## **Architectural Review Board Staff Report**

**Project Type:** Amended Architectural Elevations

**Description:** **Hampton Inn Chesterfield Lodging (AAE)**: Amended Architectural Elevations and Architect's Statement of Design for a 1.92 acre tract of land zoned "C-8" Planned Commercial District located on the north side of Swingley Ridge Rd., west of Nardin Dr.

Re Hampton Inn Exterior Renovation – Chesterfield, MO

A3.3

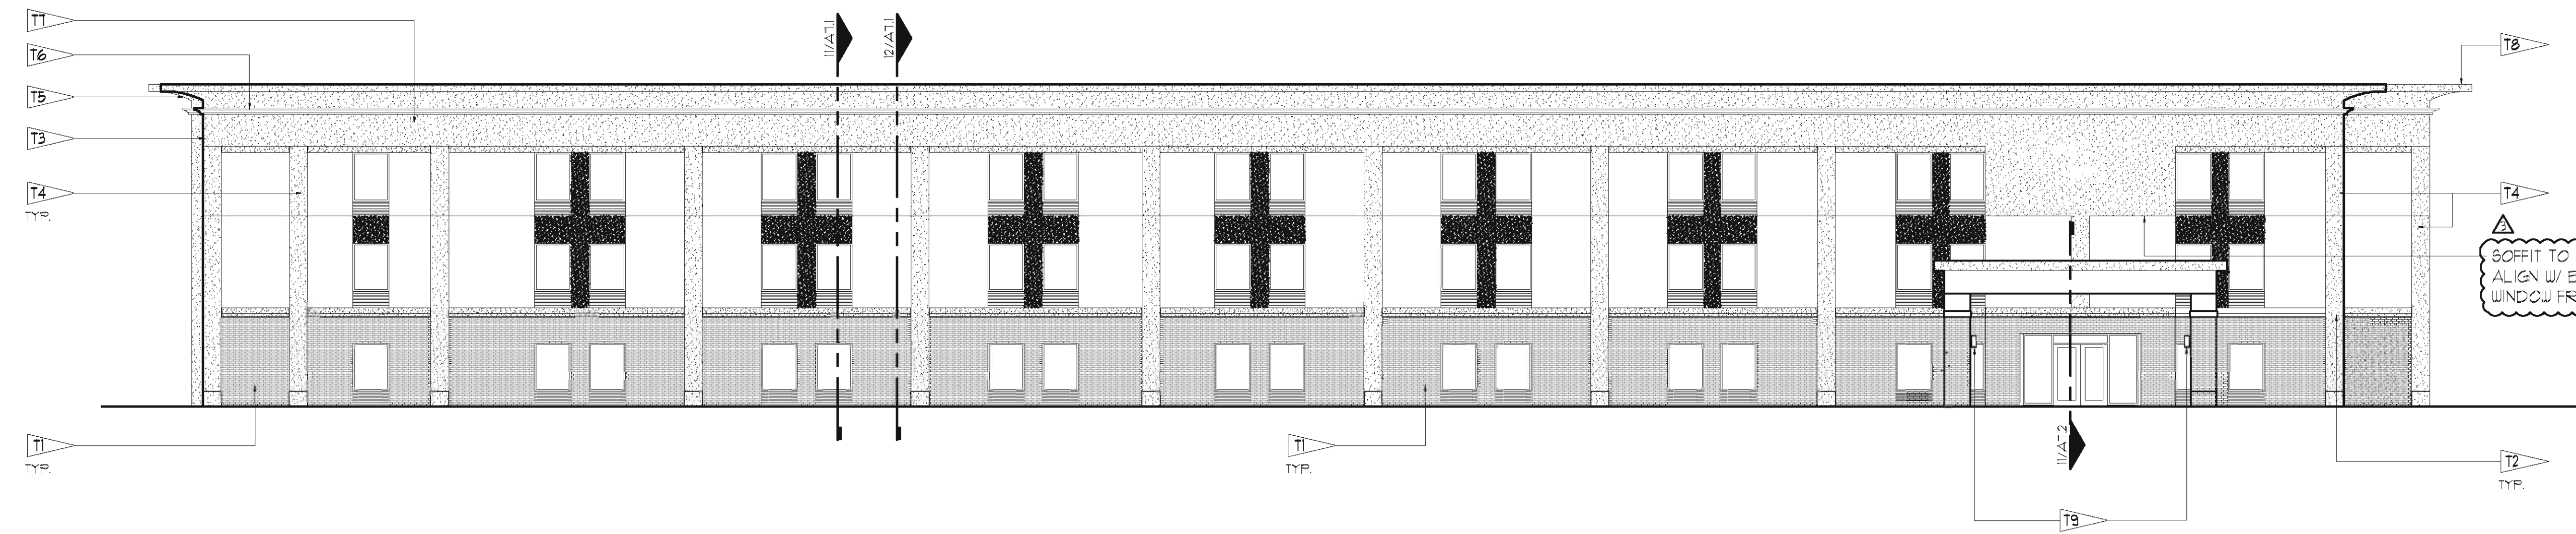
NEW PILASTERS WERE REMOVED  
CANOPY AND POOL PARAPET PROFILES CHANGED

SOFFIT TO BE LOWERED TO  
ALIGN W/ BOTTOM OF  
WINDOW FRAME

**A3.4**

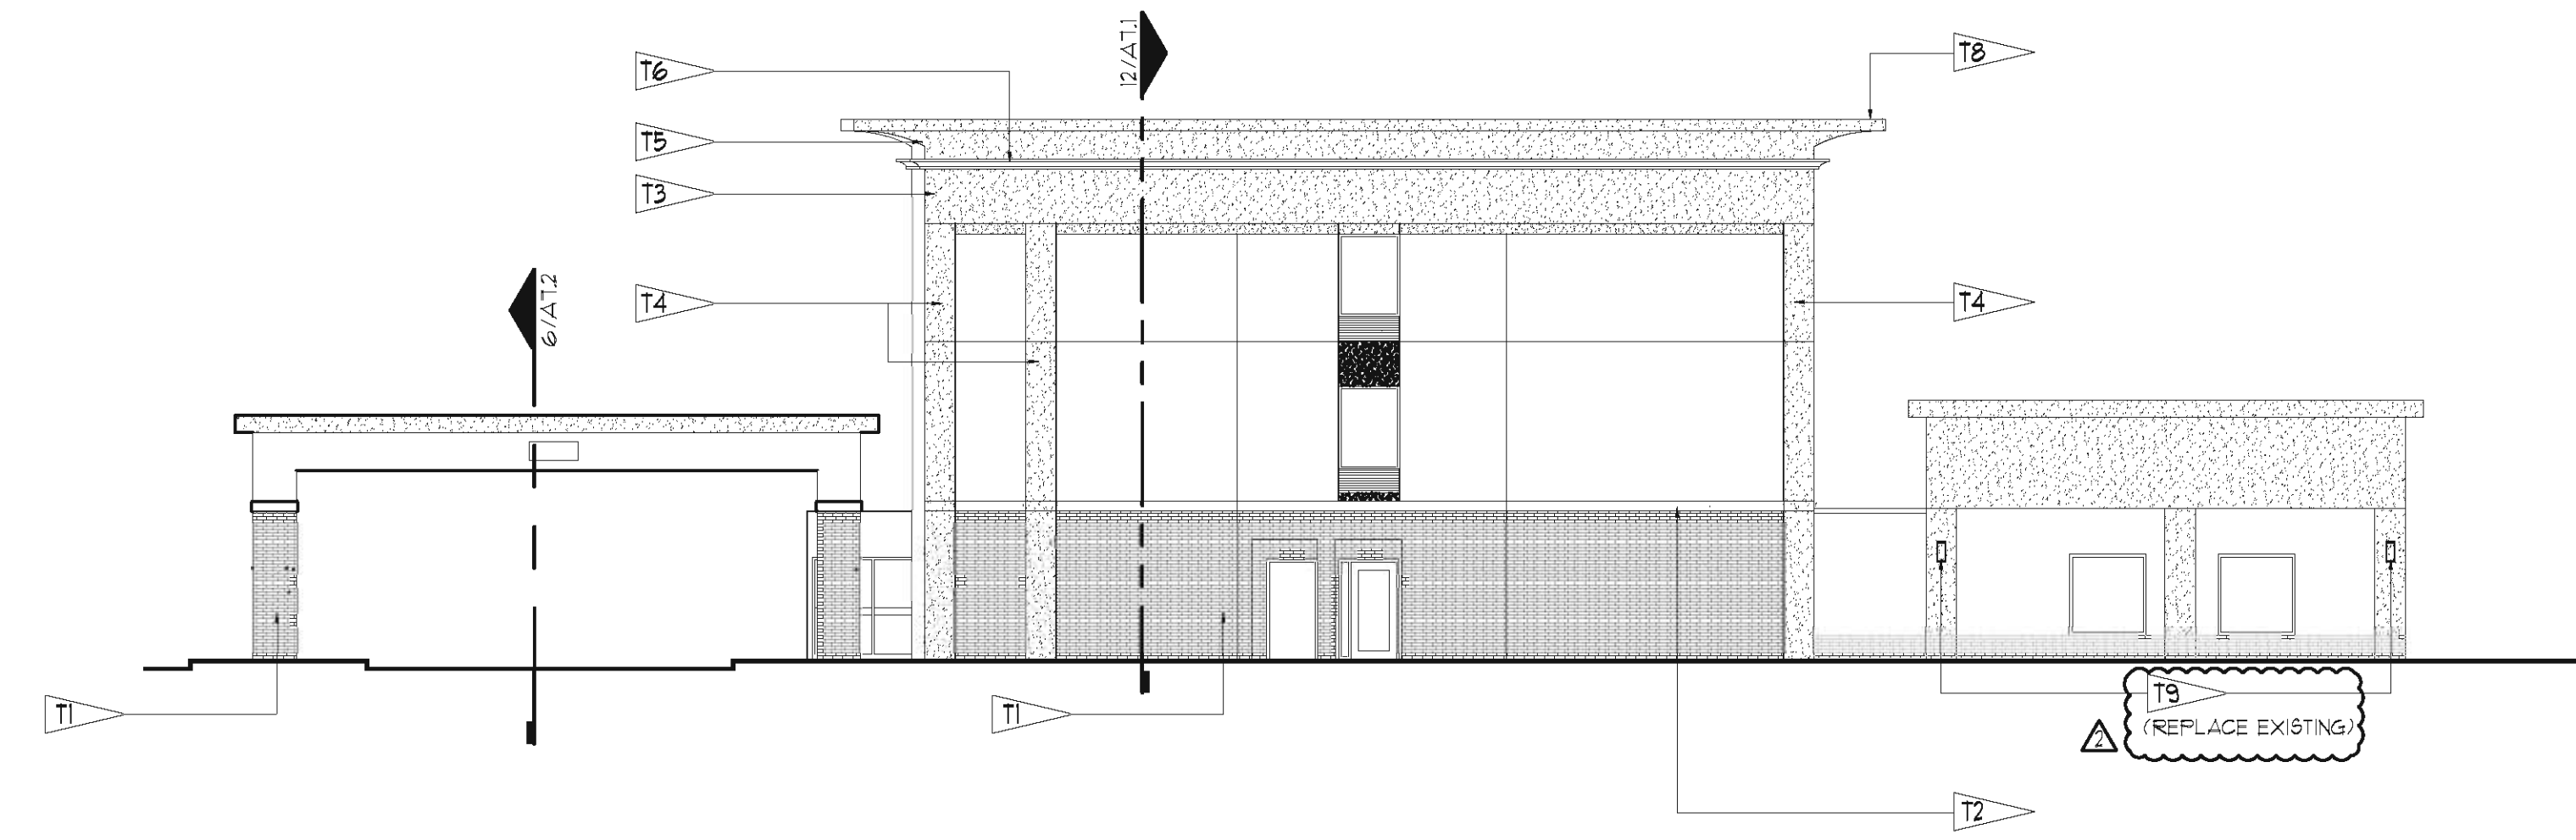
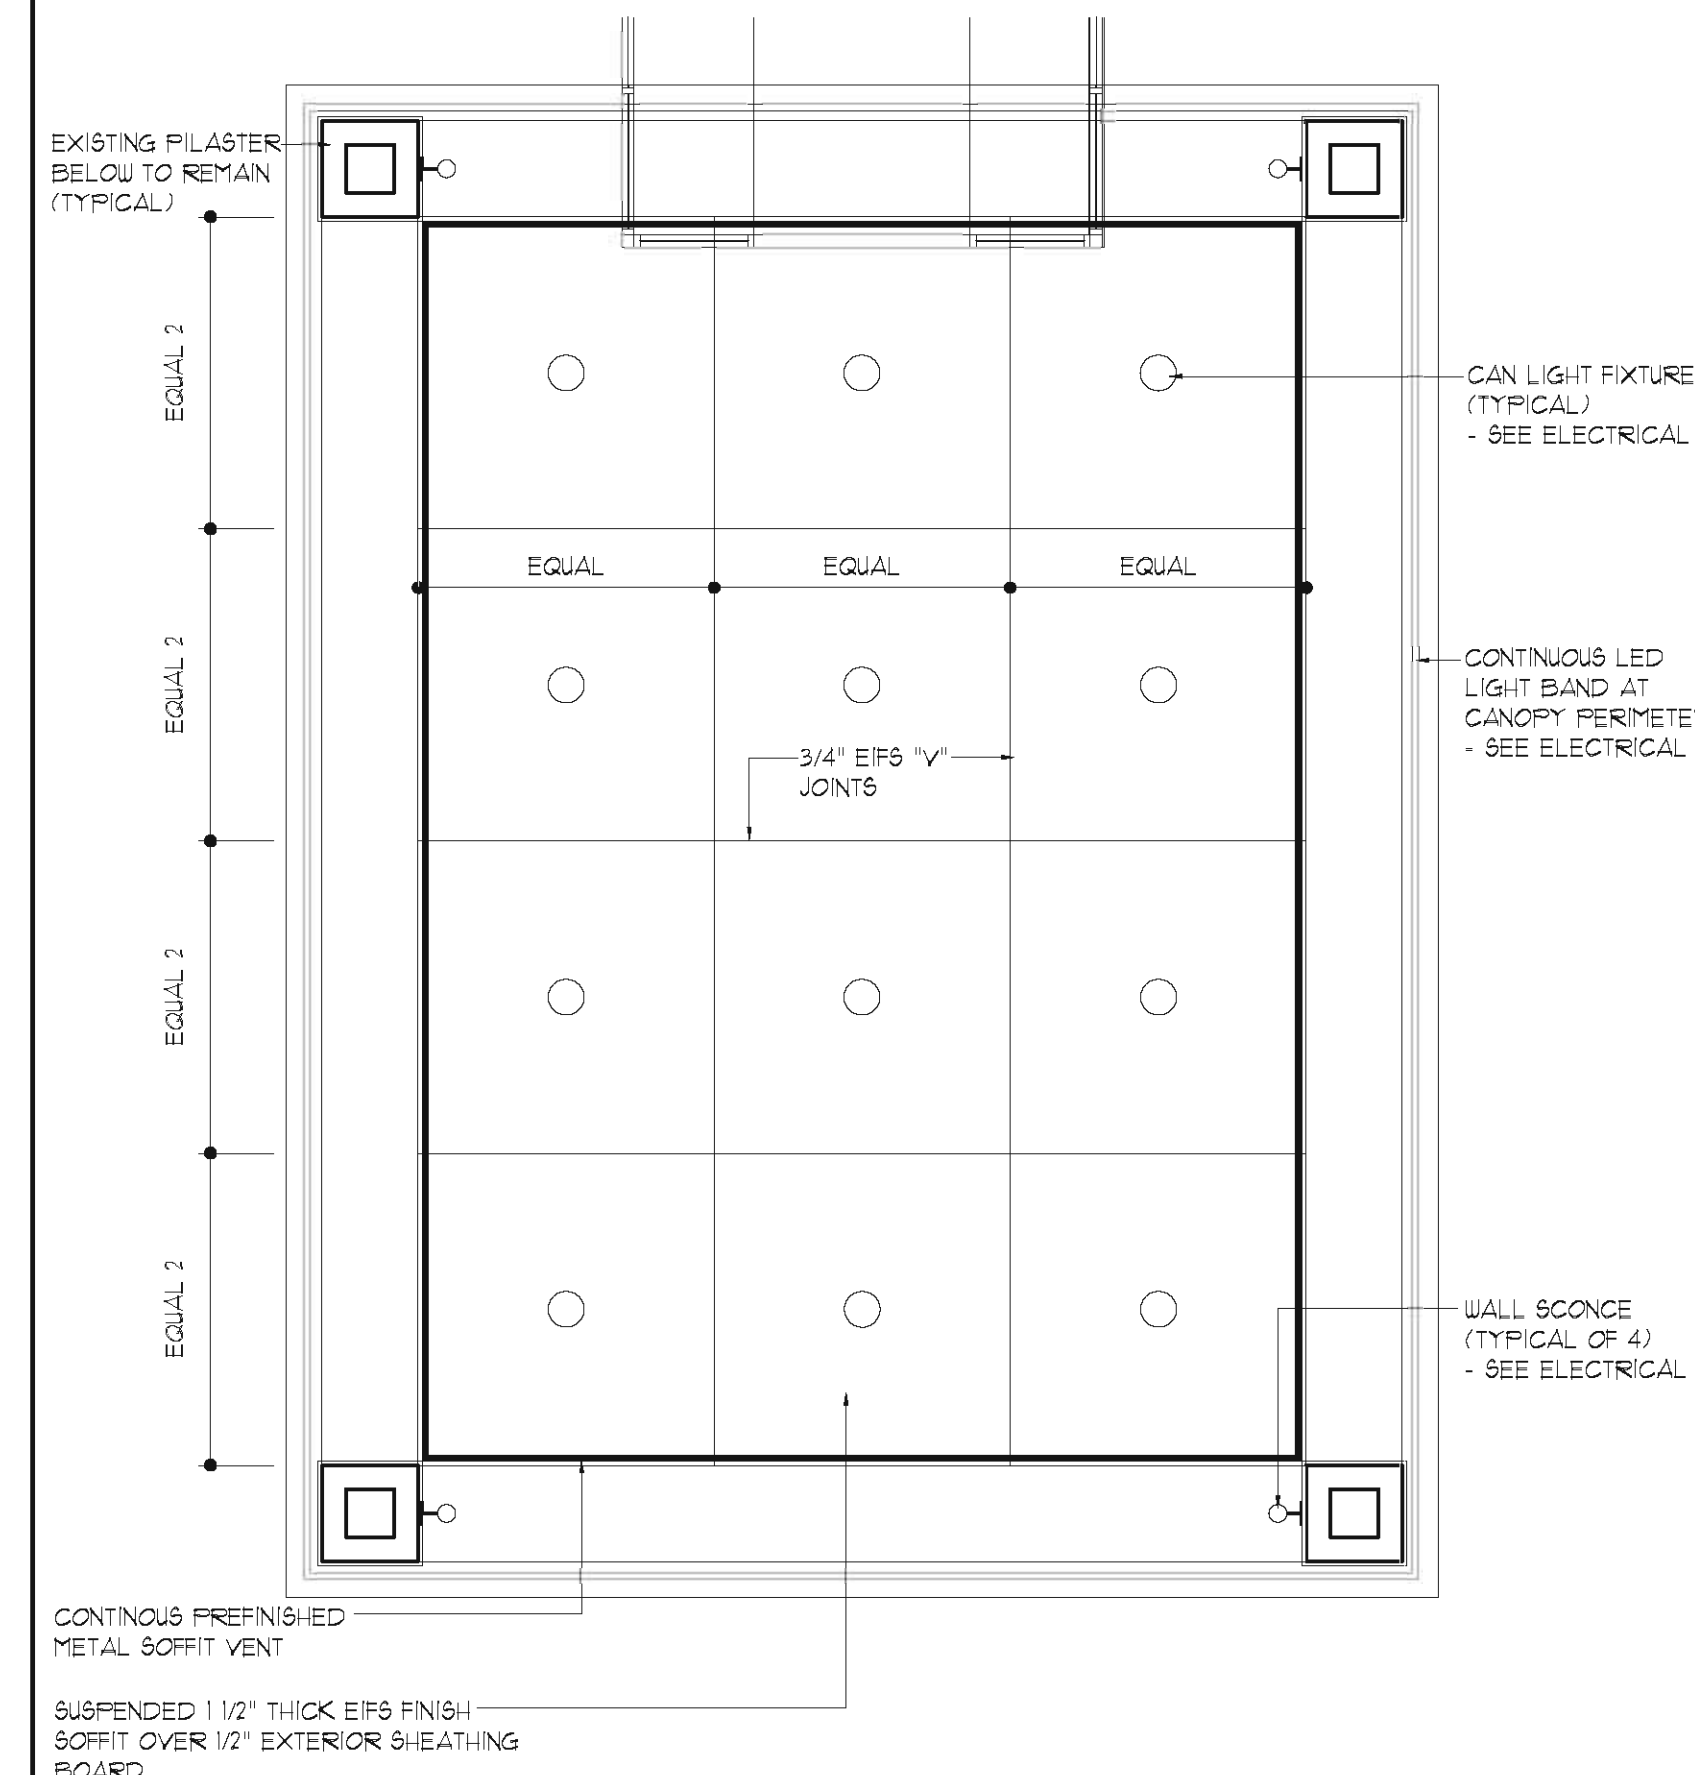
- NEW PILASTERS WERE REMOVED  
- CANOPY AND POOL PARAPET PROFILES CHANGED
